ADDENDUM NUMBER 01 TO THE BID DOCUMENTS

**BID DOCUMENT: 17/18 MB5
Building 11 Renovation # I50-35613
College of Marin – Indian Valley Campus**

Addendum Date: October 9, 2017

1 FLOOR PLAN - (E) FIRST FLOOR - ELEVATOR (2ND FLR.SIM.)

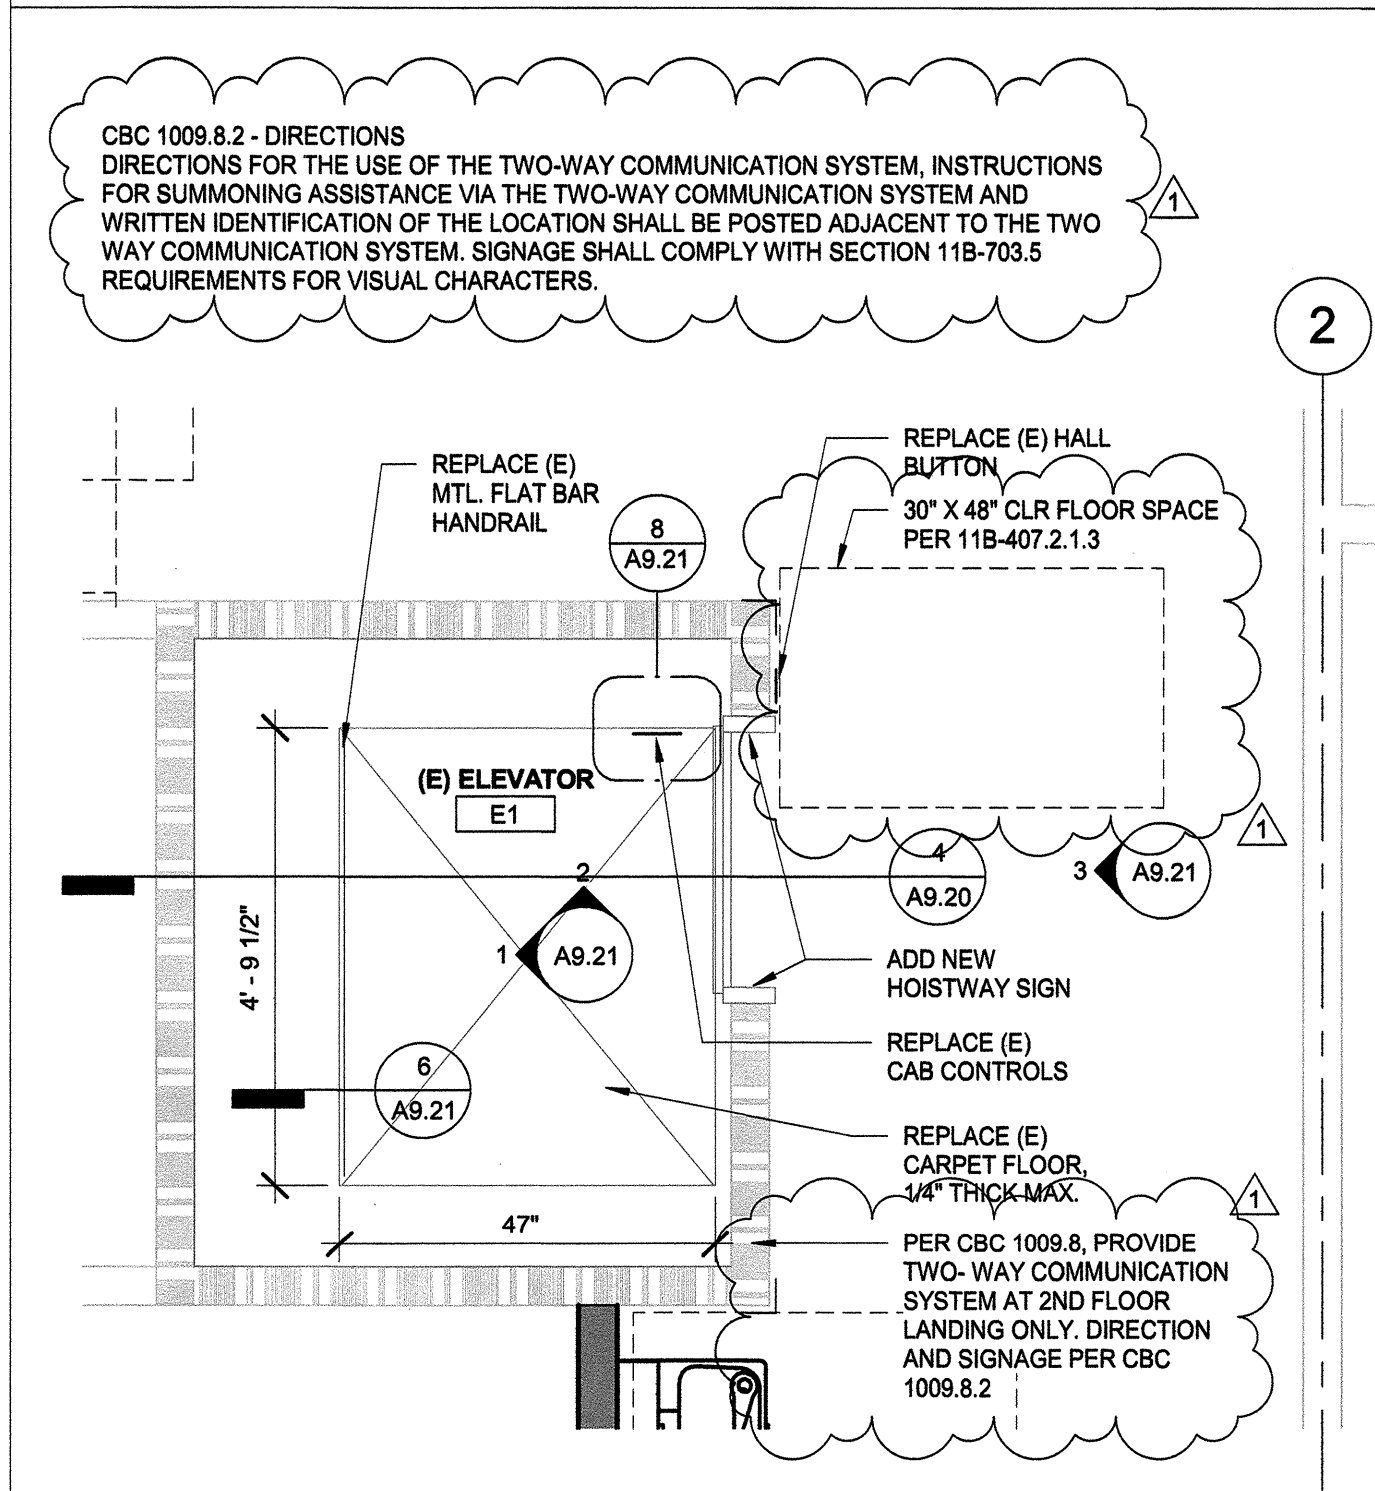
Detail: 1/A9,20 Elevator Floor Plan

- Added language to provide two-way communication device per CBC 1009.8.
- Added language for Directions for two-way communication device per CBC 1009.8.2
- Added 30"x48" clear floor space at elevator hall control per CBC 11B-407.2.1.3

6 ELEVATOR SUPPORT RAIL 3" = 1'-0"

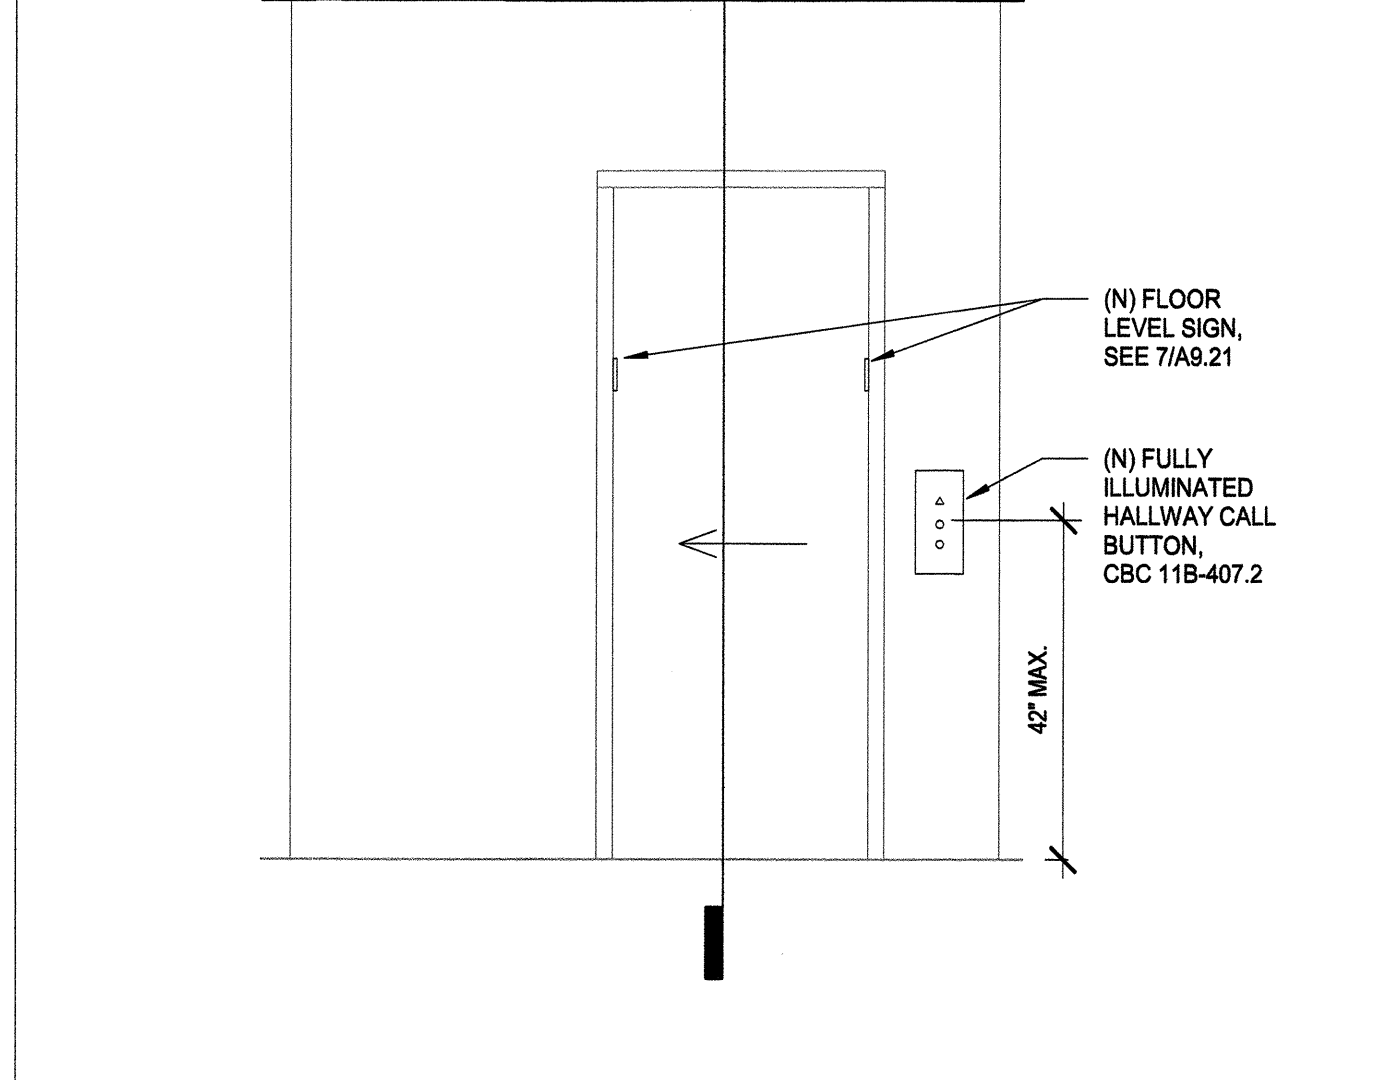
Detail 6/A9.21 Elevator Support Rail

- Added language for stainless steel handrail allowable stresses and mounting requirements inside elevator cab.

2 ELEVATOR CAB SIDE ELEVATION 1/2" = 1'-0"

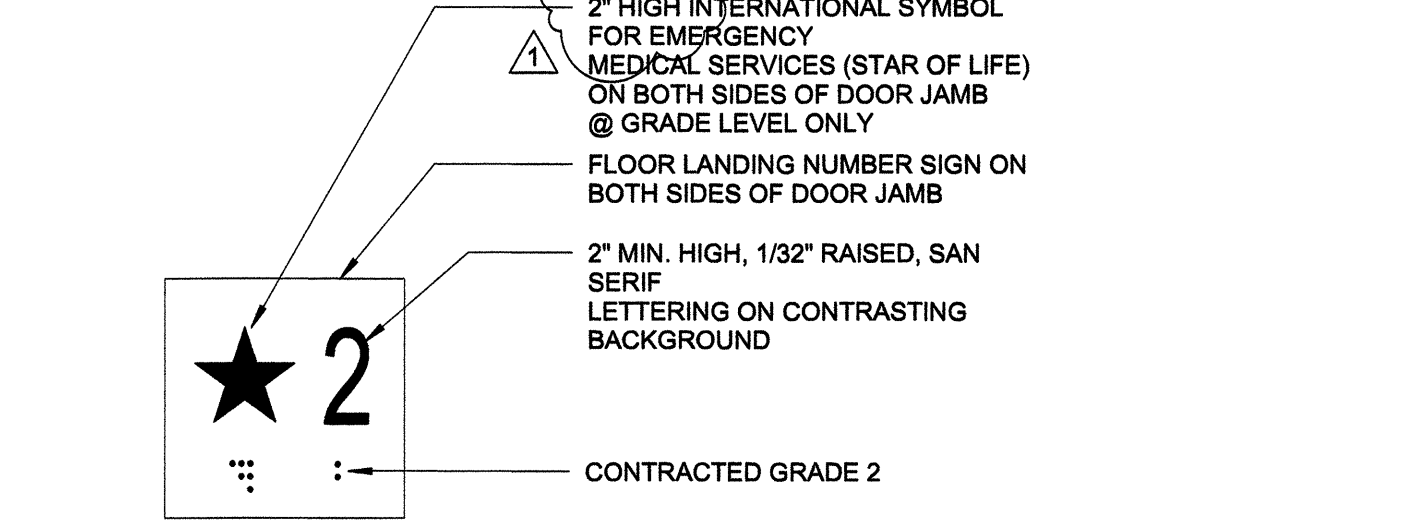
Detail 2/A9.21 Elevator Cab Side Elevation

- Added language for car position indicator per CBC 11B-407.4.8

4 ELEVATOR DOOR SILL - WOOD 3" = 1'-0"

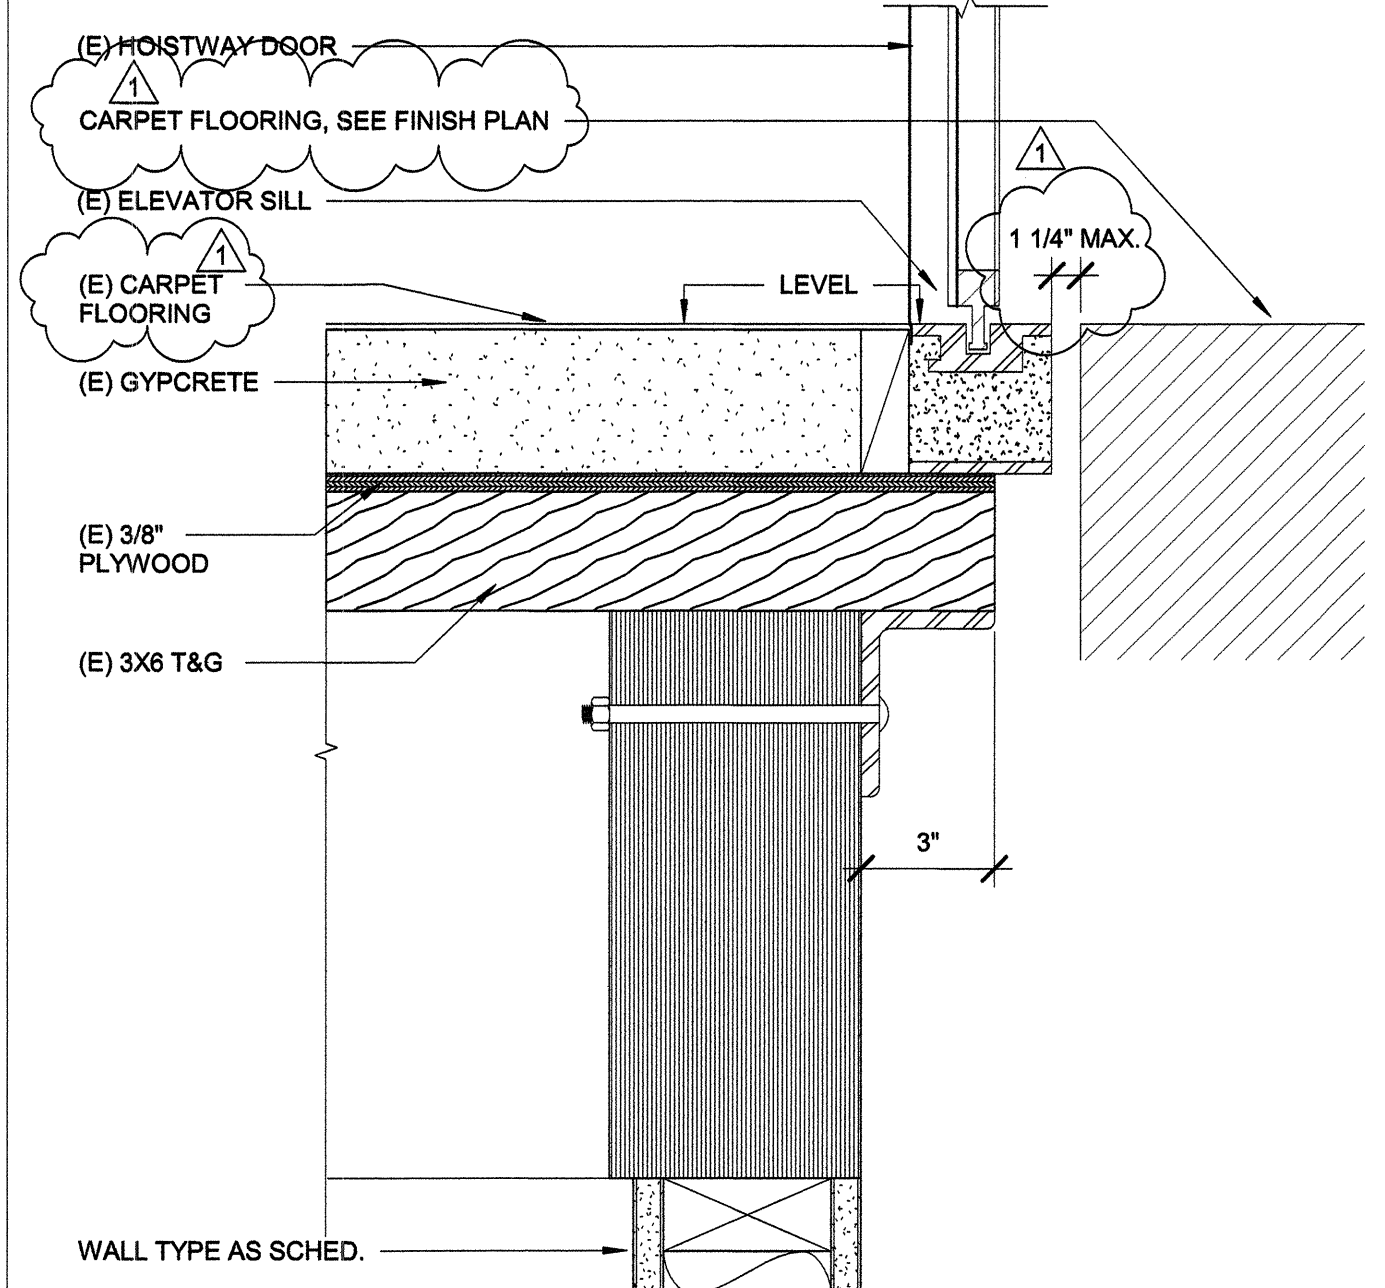
Detail 4/A9.21 Elevator Door Sill - Wood

- Added clearance dim. at elevator and hoistway transition
- Clarified flooring material at elevator and existing adjacent flooring

1 ELEVATOR CAB BACK WALL ELEVATION 1/2" = 1'-0"

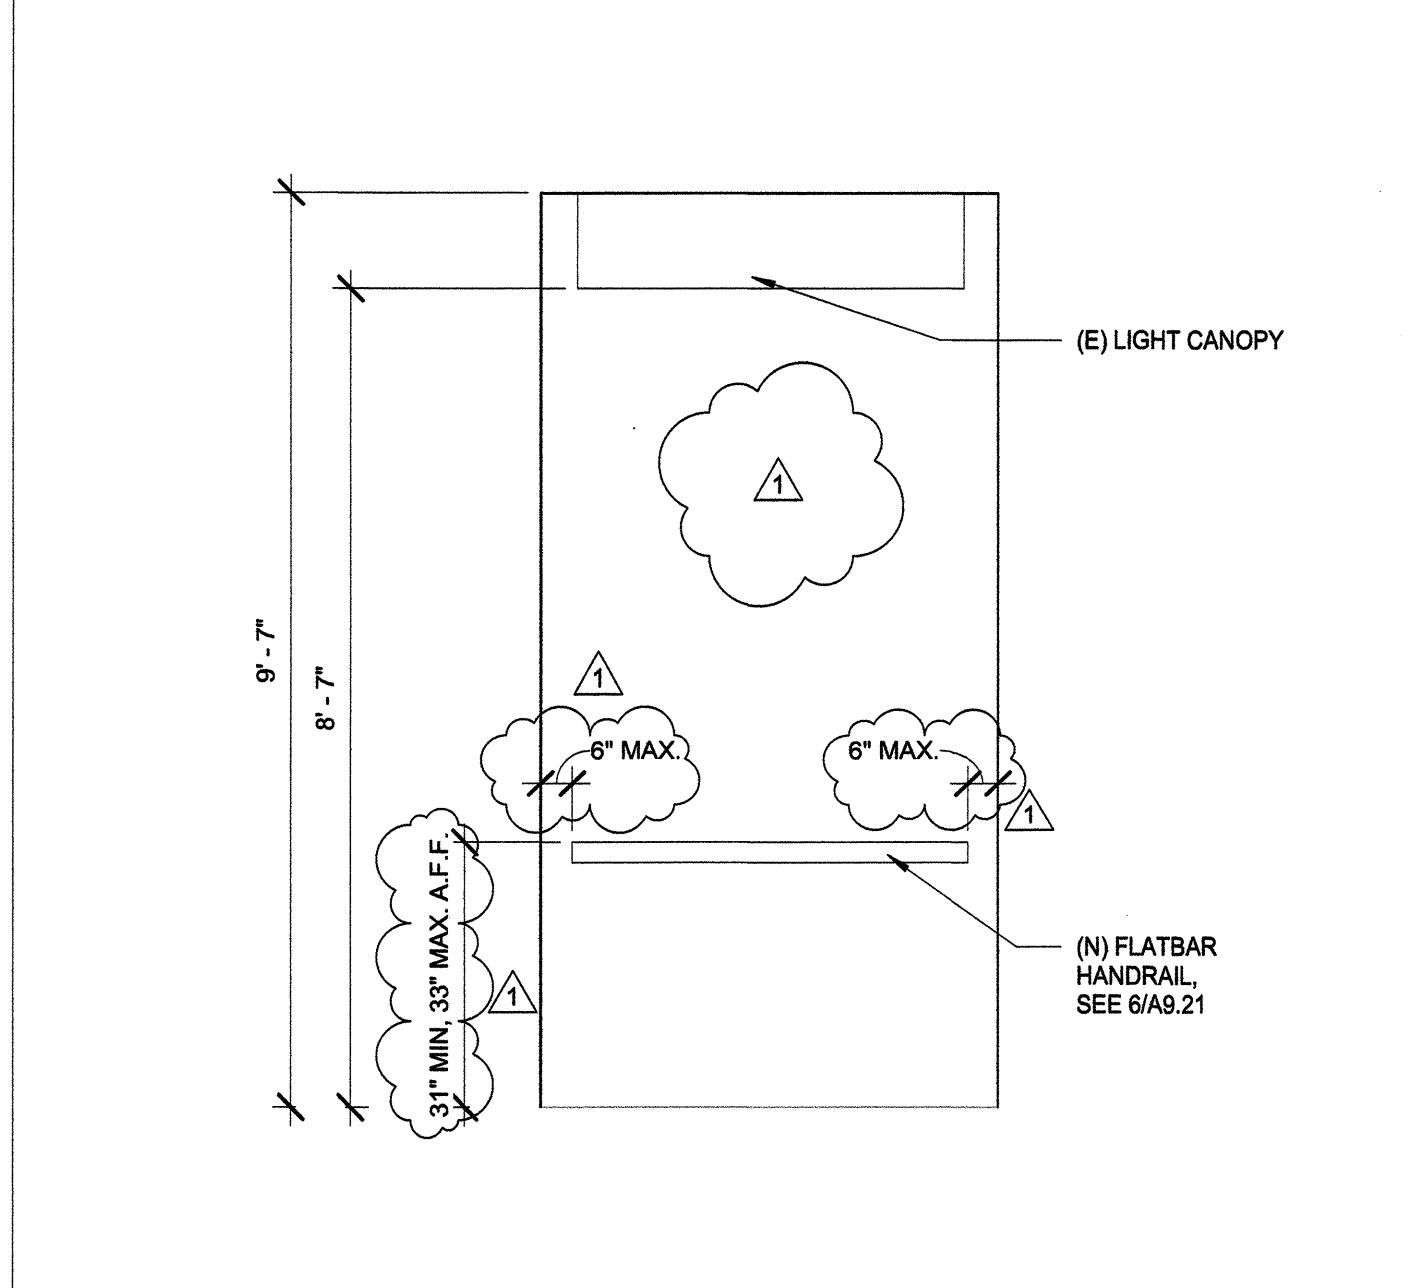
Detail 1/A9.21 Elevator Cab Back Wall Elevation

- Added notation for 6" max clearance for handrail
- Clarified mounting height for handrail
- Removed car indicator from back wall
